SUBJECT: RESULTS OF THE DIABLO CANYON UNIT 1 NATURAL CIRCULATION, BORON MIXING, AND COOLDOWN TEST EVALUATION

Re: Watts Bar Nuclear Plant, Units 1 and 2.

SUBJECT: DIABLO CANYON CONFORMANCE WITH BRANCH TECHNICAL POSITION
RSB 5-1 REGARDING NATURAL CIRCULATION, BORON MIXING, AND COOLDOWN

Figure 4.1 Margin of subcooling in the upper head with CRDM fans in operation.

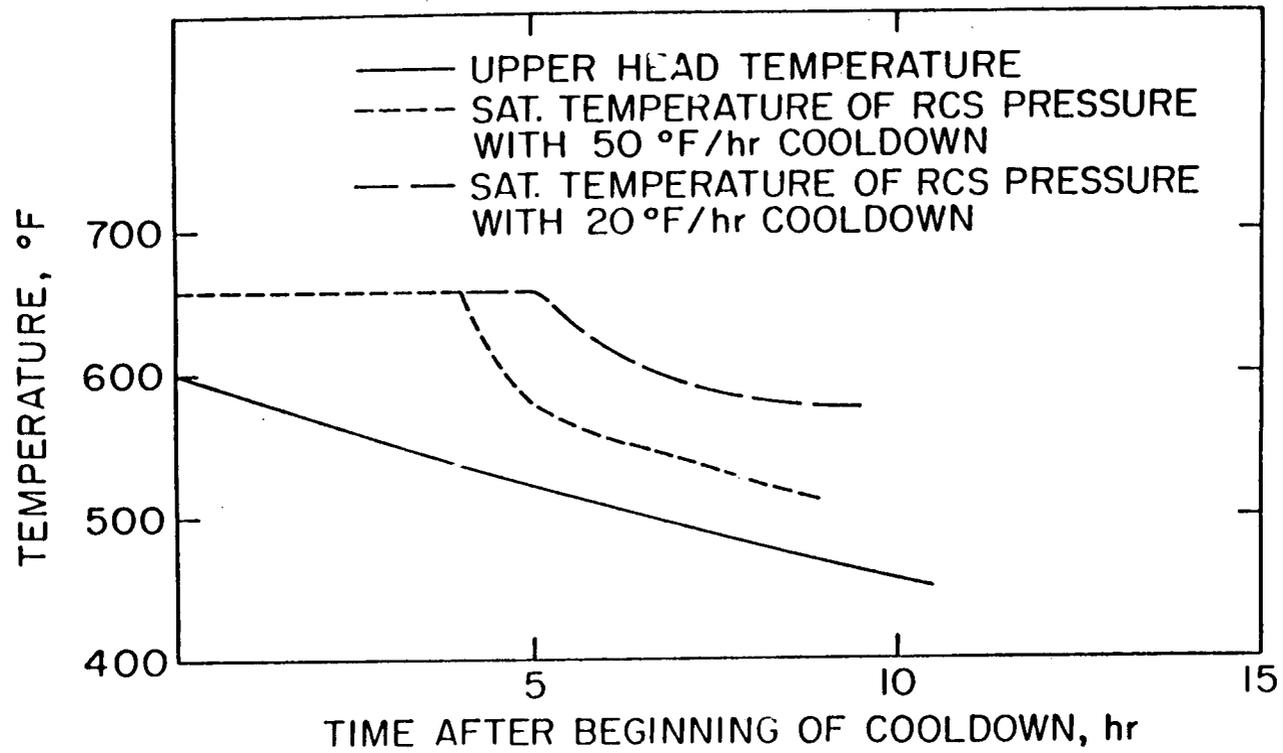
The CRDM fans have a major impact on the cooling of the upper head. With CRDM fans operating, the reactor vessel upper head would be cooled at approximately 20°F per hour. Without them, the cooling time of the RCS would increase by 20-30 hours and about 180,000-240,000 gallons of additional cooling water would be required. It would also increase the possibility of void formation during the cooldown/depressurization period.

Figure 4.3 Upper head temperature and saturation temperature of RCS pressure with 20°F/hr cooldown.

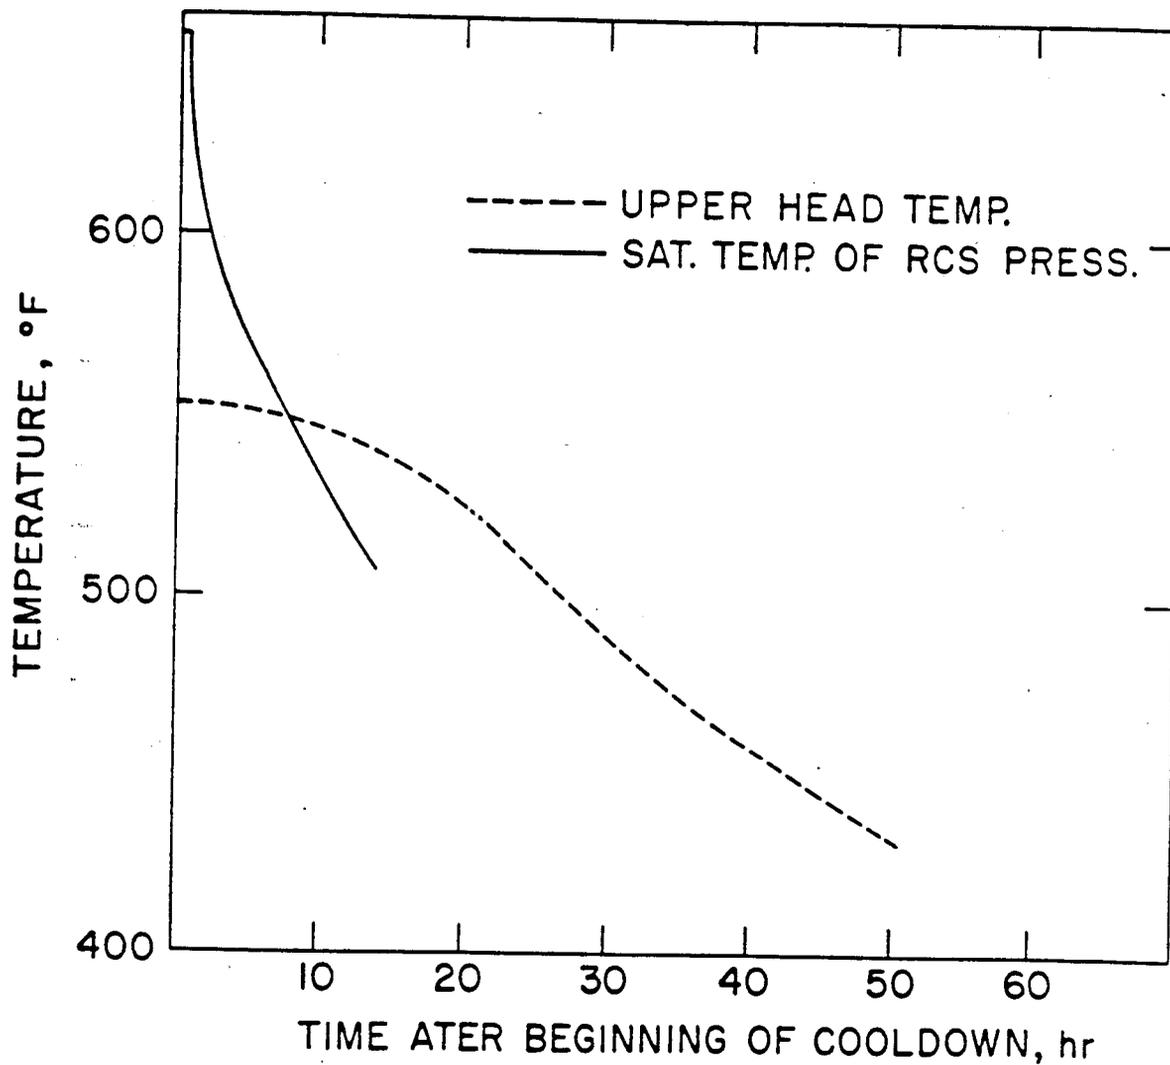
Figure 4.3 compares the upper head temperature calculated by BNL with the saturation temperature corresponding to the RCS pressure with 20°F/hour cooldown rate. It showed that the saturation temperature of the RCS pressure may go below the upper head temperature and thus a void may form during the cooldown operation even with a low cooling rate of 20°F/hour without the CRDM fans in operation unless the RCS pressure was maintained by means of either the pressurizer heaters or charging. The pressure would decrease slowly due to RCS cooldown contraction and ambient heat loss in the pressurizer. The rate of pressure drop due to pressurizer heat loss was estimated to be approximately 80 psia/hour.
